Enclosure 3
Westinghouse APP-GW-GLR-607, Revision 2
(NON-PROPRIETARY VERSION)
(63 pages including cover page)

Changes to Passive Core Cooling System Condensate Return

Changes to Passive Core Cooling System Condensate Return

Figure 8: Personnel Airlock Gutter Modification Schematic

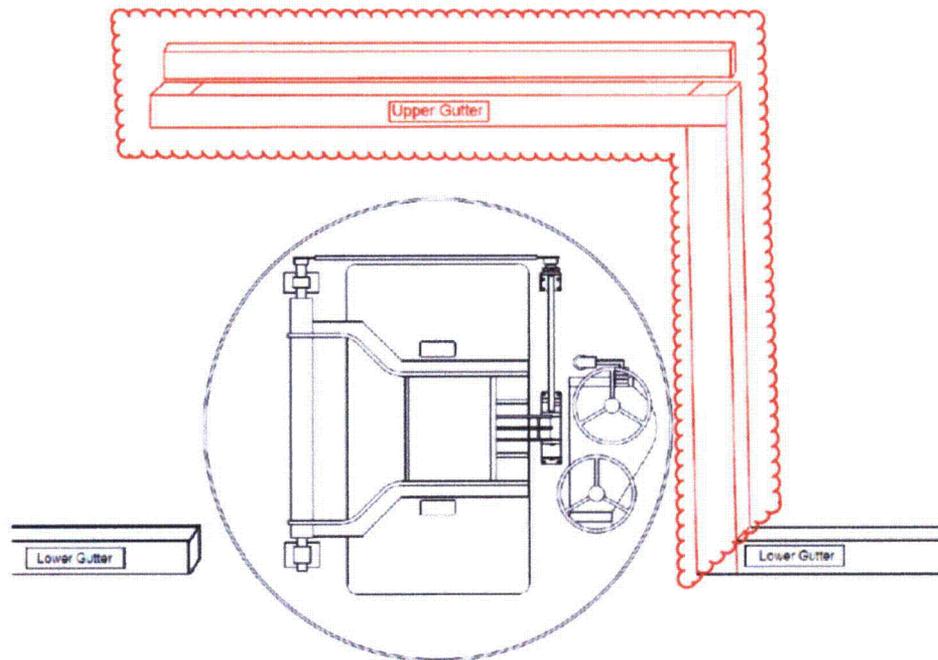
The original IRWST gutter was routed to the edges of the Upper Personnel Airlock and Upper Equipment hatch. [

]^{a, c} The IRWST gutter will be modified to have an upper gutter above each of the hatches that connects with the existing gutter. The extended gutter is of the same size as the sections which currently interface with the sides of the hatches. The gutter is sloped the same as the existing portions of the gutter. The extended portion of the gutter above the Upper Personnel Airlock is routed to interface with the lower portion of the gutter. Figure 8 shows a schematic of the proposed modification to the IRWST gutter to above the Upper Personnel Airlock. The Upper Equipment Hatch is similarly treated.

Figure 6.3-1
Passive Core Cooling System
Piping and Instrumentation Diagram (Sheet 1 of 3)

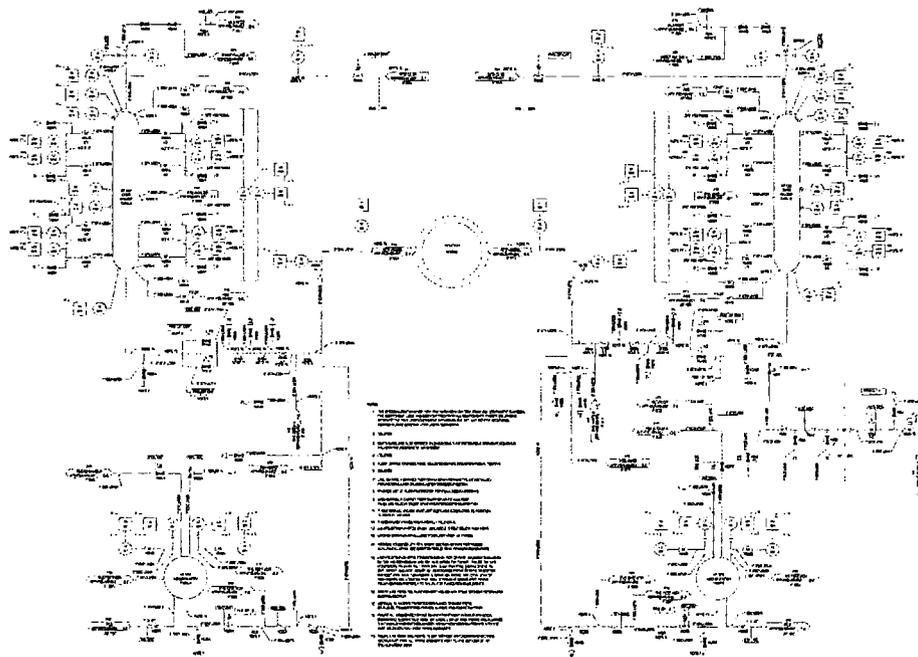
To reflect the changes to the PXS system, the additional downspout piping is captured in the gutter discussions of UFSAR subsection 6.3 and on a new sheet of the PXS piping and instrumentation diagrams (P&IDs). In order to add the new P&ID sheet to the licensing basis, Figure 6.3-1 will be expanded to include all sheets of the PXS P&IDs and Figure 6.3-2 will not be used.

- Subsection 6.3.1.1.1 would be updated to describe the downspouts in the safety-related design criteria.
- Subsection 6.3.2.1.1 will be updated to include the intermediate collection points of the safety-related gutter arrangement.
- Subsections 6.3.2.2.7 and 6.3.2.2.7.1 would be updated to clarify the number of screen sets in the PXS and to which set of screens the criteria in this section apply.
- Subsection 6.3.2.2.7.2 would be updated to clarify the condensate return gutter arrangement related to LOCA operation.
- Figure 6.3-1 will be relabeled Figure 6.3-1 (Sheet 1 of 3). This editorial change is the only change made to this figure. No technical changes are made.
- Figure 6.3-2 will be relabeled Figure 6.3-1 (Sheet 2 of 3). On relabeled Sheet 2, the IRWST gutter has been relocated to a new sheet 3 of the PXS P&IDs. Sheet 2 has been

Figure 6.3-1
Passive Core Cooling System
Piping and Instrumentation Diagram (Sheet 3 of 3)
(REF) PXS 005

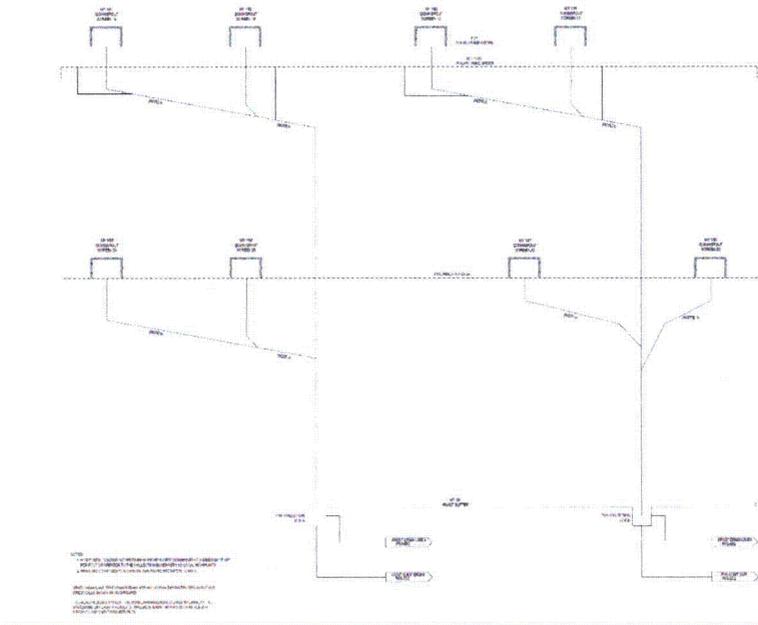
- Figure 6.3-1 (Sheet 3 of 3) is a new P&ID sheet and will be added to the licensing basis. This new figure shows the relocated IRWST gutter and the screens and piping comprising the PXS downspouts originating from the Polar Crane Girder and internal stiffener.
- Figure 6.3-2 will not be used.
- The Chapter 6 List of Figures will be updated to reflect the PXS figure relabeling and the additional PXS P&ID sheet.
- Reference to Figure 6.3-2 in subsection 6.3.2.1 is changed for consistency.

Figure 19E.4.10-1

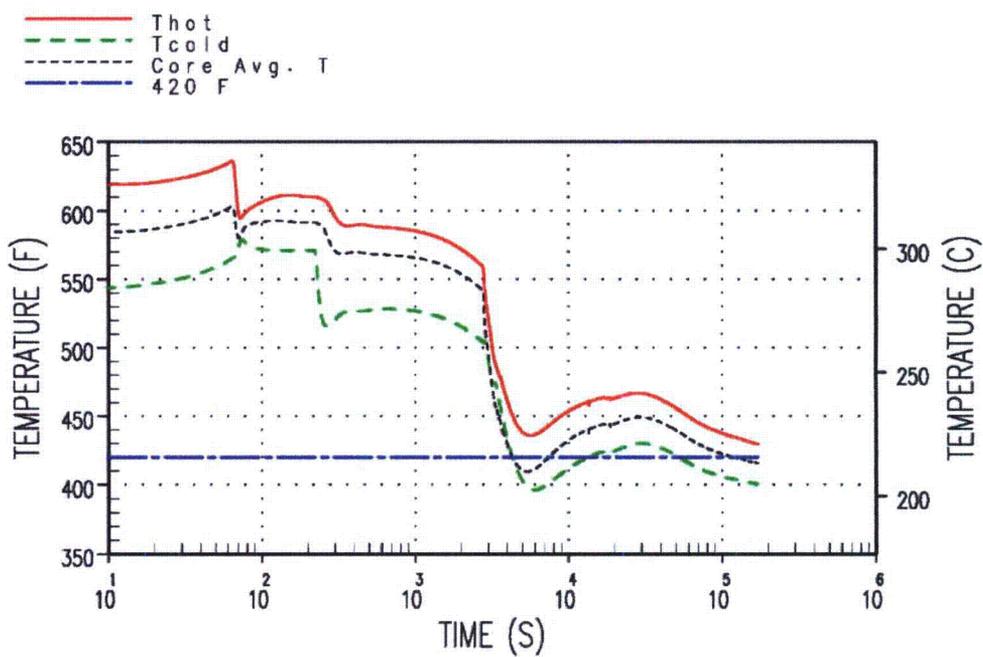
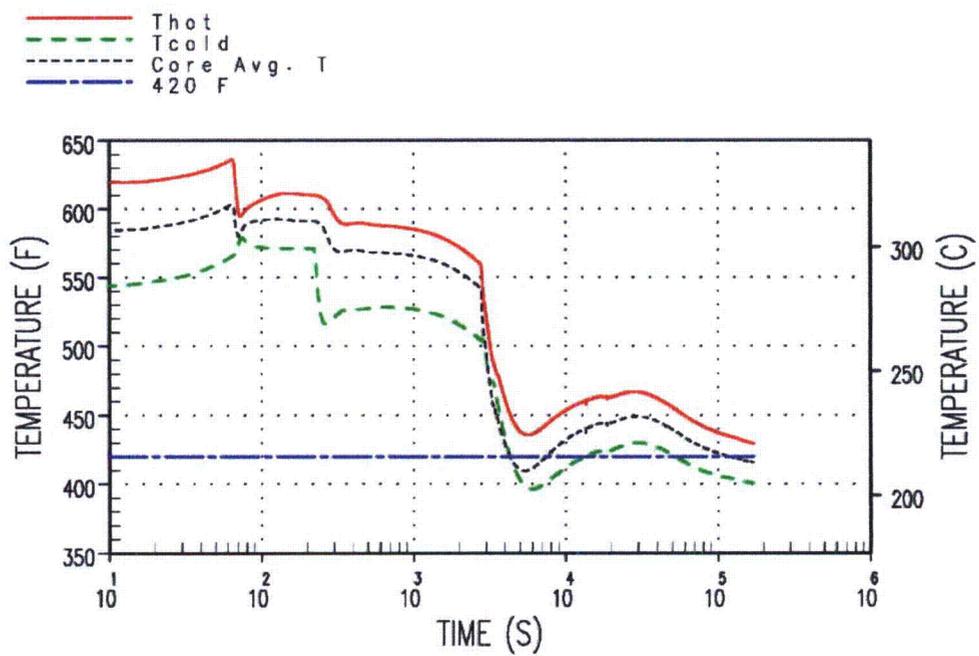
Based on the updates to the safe shutdown evaluation, the supporting licensing basis tables and figures need to be updated to reflect the current design. Section 19E.4.10.2, Table 19E.4.10-1, and the supporting figures, Figure 19E.4.10-1, -2, -3, and -4 will be updated by this change package.

The safe shutdown temperature evaluation was revised to address the effects of the design modifications and supporting analyses and calculations of condensate return to the IRWST on PXS performance. **The revised evaluation is reflected in the description provided in section 7.4 and subsection 7.4.1.1.** The resultant changes to the Chapter 19 shutdown temperature evaluation are shown in text revisions to subsection 19E.4.10.2, changes to Table 19E.4.10-1, and changes to Figures 19E.4.10-1 through 19E.4.10-4.

46,700 seconds, the PRHR heat transfer matches decay heat and it continues to operate to reduce the RCS temperature to below 420°F within 36 hours. As seen from Figure 19E.4.10-1, the cold leg temperature in the loop with the PRHR is reduced to 420°F within 52,900 seconds, while the core average temperature reaches 420°F within 120,900 seconds (approximately 34 hours).
